**Landscape Review Committee
 ZOOM Online Meeting
 September 16, 2020 - 12:00 PM**

DATE: September 16, 2020
TO: Landscape Review Committee Members
FROM: Jamie Fleckenstein, Associate Planner
SUBJECT: Agenda Item 4A – Landscape Plan Review Application (L 21-20)

DECISION, CONDITIONS, FINDINGS OF FACT AND CONCLUSIONARY FINDINGS FOR THE APPROVAL OF A LANDSCAPE PLAN REVIEW FOR AN URGENT CARE CLINIC AT 1755 SW BAKER STREET

Figure 3: Proposed Landscape Plan

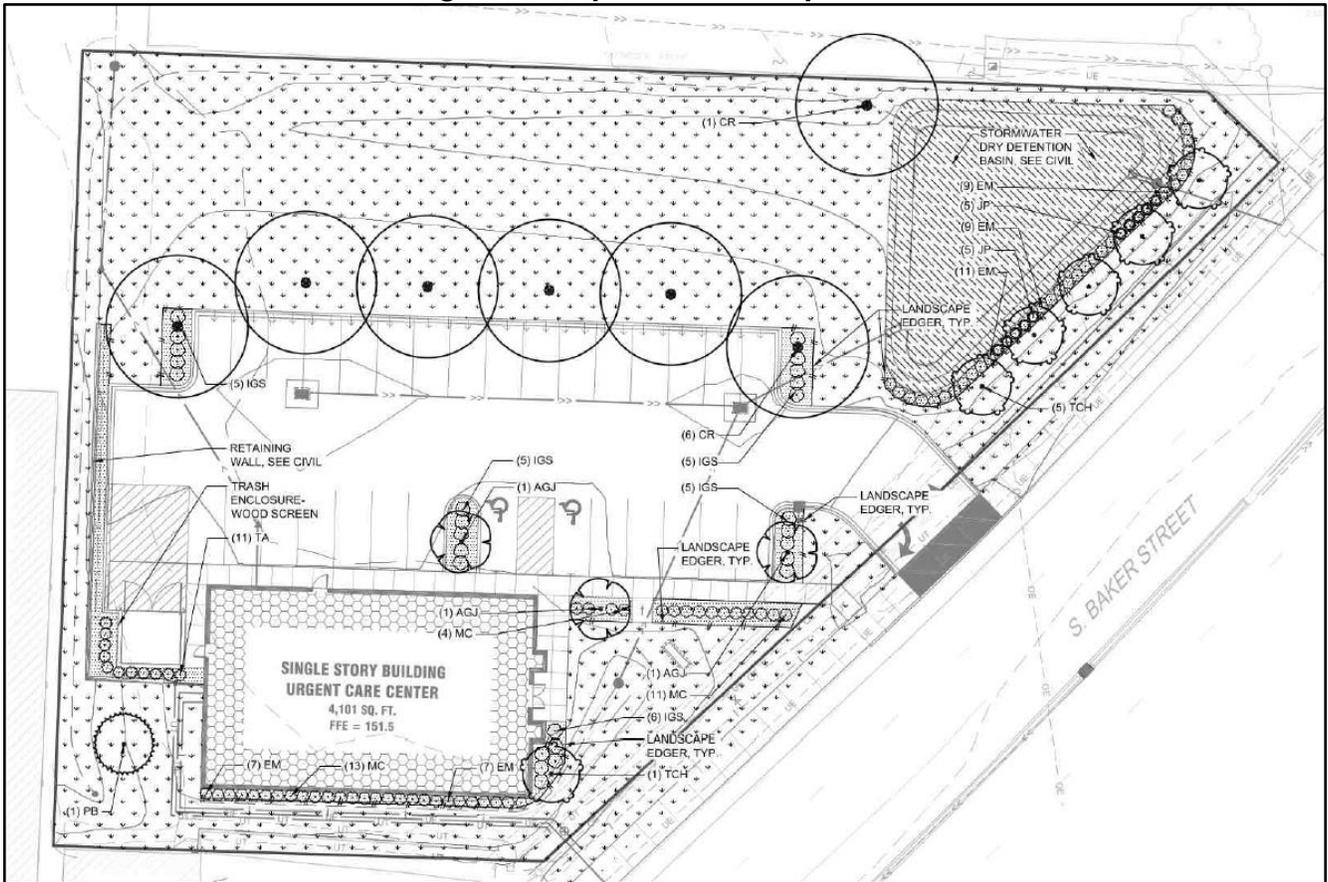
2. 17.57.070(B)(2) requires screening of the proposed use, typically through the location of trees, screening plantings, or other screens around the perimeter of the site or other key locations on the property. It does not appear that screening of uses (clinic building, off-street parking) is addressed in a meaningful way.

3. 17.57.070(B)(4) requires planting and islands to break up parking lots. A stated purpose and intent of the Landscaping Chapter is to provide "parking lot landscaping to reduce the harmful effects of heat, noise and glare associated with motor vehicle use" (MMC 17.57.010(A)(4)). No planting islands or perimeter planting around the parking area is provided that would help accomplish the purpose of the code.

We will remove one (1) parking stall on the south side of the parking lot and create a landscaped island with one (1) tree and additional shrub plantings. (September 9, 2020)

FINDING: SATISFIED. Planting consisting of evergreen shrubs and deciduous shade trees is proposed at three corners of the parking lot and along the edge of the parking area most visible from the public right-of-way. A row of deciduous trees borders the northern edge of the parking lot. An internal parking lot island with planting breaks up the southern parking aisle adjacent to the

SITE RESTORATION & PLANTING PLAN

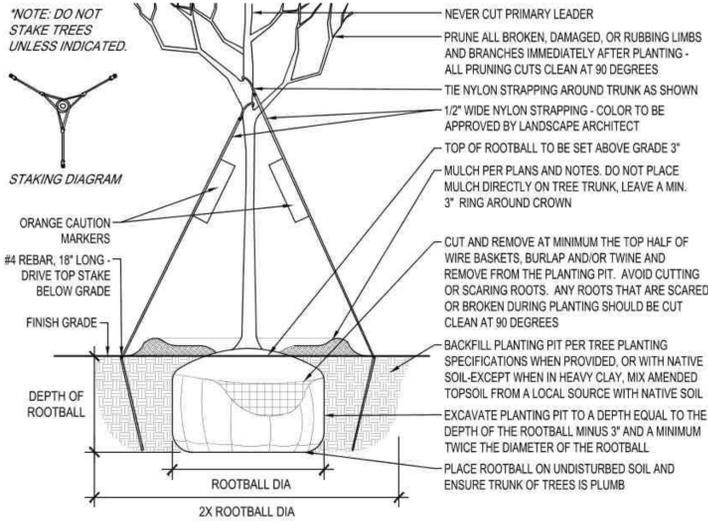
1. Provide additional shade trees along the property's frontage to provide additional screening and buffering of proposed use. Specifically, the LRC noted the opportunity to provide additional trees between the detention basin and the right-of-way to provide more of a transition from the detention basin planting and a street-tree like atmosphere along the right-of-way. The LRC also noted opportunity to provide a shade tree between the urgent care clinic and the right-of-way to provide additional screening without obstructing visibility of proposed signage or building entrance. The LRC commented that additional trees could be *Tilia cordata* 'Halka' (Summer Sprite Linden) to match those already proposed, and that there appeared to be room for three (3) additional Lindens next to the detention basin and one (1) Linden southeast of the building entrance.

1. Replace one (1) parking stall on the south side of the parking lot with a planting island with a deciduous tree and other plantings to break up the parking aisle.

2. Provide additional deciduous shade trees at a regular spacing on the north side of the parking lot to help reduce the harmful effects of heat, noise, and glare associated with motor vehicle use. The LRC commented that additional shade trees could be *Celtis reticulata* (Western Hackberry) to match those already proposed near the parking lot, and that approximately 30 foot spacing of the trees could provide sufficient shade and benefit. The LRC also noted that additional trees on the north side of the parking lot would reduce or eliminate the need for the evergreen trees in the open lawn area.

ISG Response: We will provide four (4) appropriate additional deciduous trees along the frontage of the property in appropriate locations that avoid the proposed signage and underground utilities.

We will remove one (1) parking stall on the south side of the parking lot and create a landscaped island with one (1) tree and additional shrub plantings.

ISG Response: We will provide four (4) additional shade trees on the north side of the parking lot at approximately 30' spacing and remove the three (3) Colorado Blue Spruce from the open lawn area adjacent to the parking lot.
